V8 XJ Series/XK

600-03

Part-Load Engine Breather – Partial Blockage of Restrictor – Scheduled Cleaning – Service Action S474

Remove and destroy Bulletin 600-03, amended 11/00.
Replace with this Bulletin.
Revisions are marked with a bar and in **bold text**.

ILLUSTRATION 1

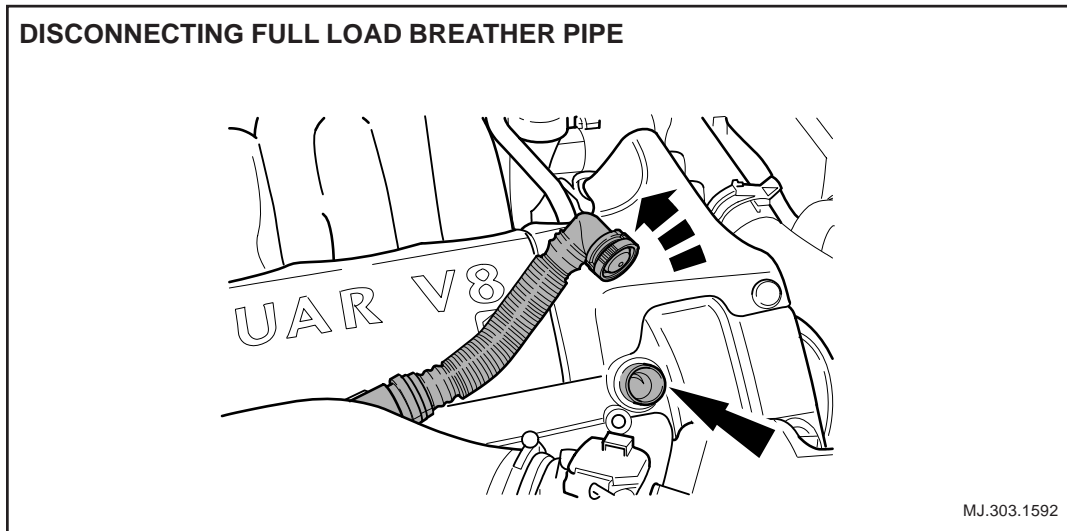
1. Open the hood. Cover the fenders with protective fender covers.
2. On normally aspirated engines, remove the engine cover from the left cylinder bank.
3. Start the engine.
4. Disconnect the full load breather line on the right camshaft cover, (Illustration 1).

ILLUSTRATION 2

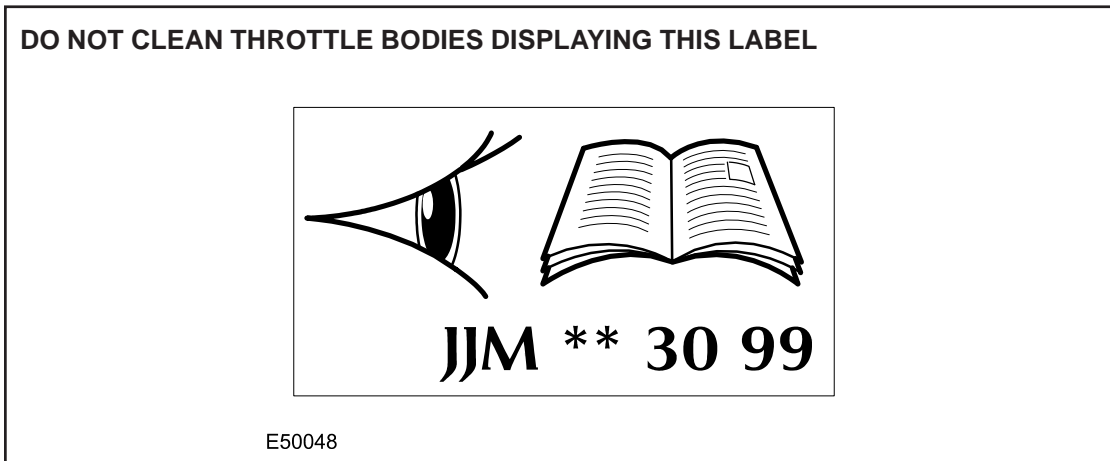
⚠ Caution: If the throttle body displays the label shown in Illustration 2, do not clean the throttle body bore and butterfly valve as damage to the vehicle can result.

ILLUSTRATION 3

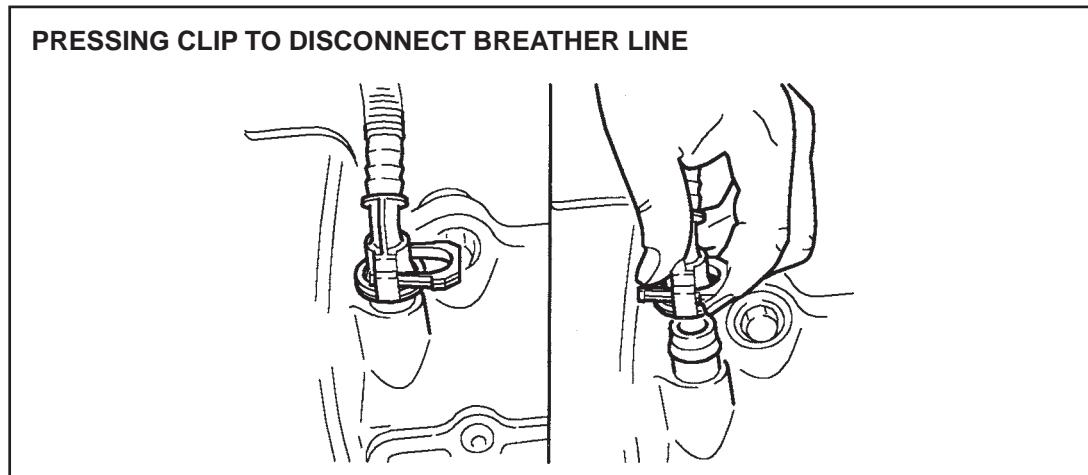
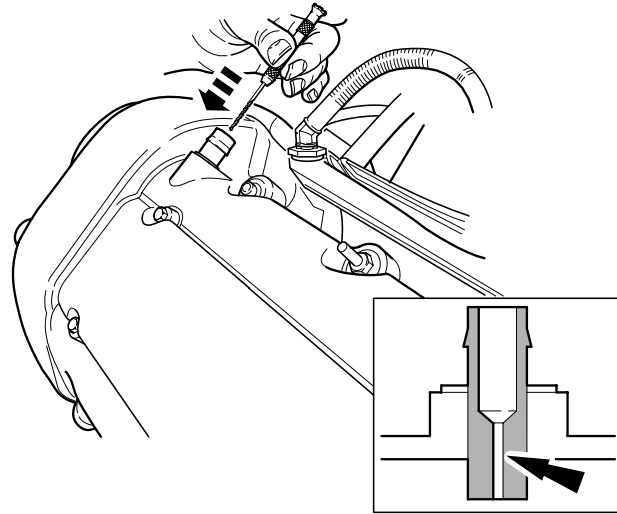
6. Depress the retaining clip (Illustration 3) of the connector of the part-load breather line, allowing the line connector to be disconnected from the breather stub on the left camshaft cover.
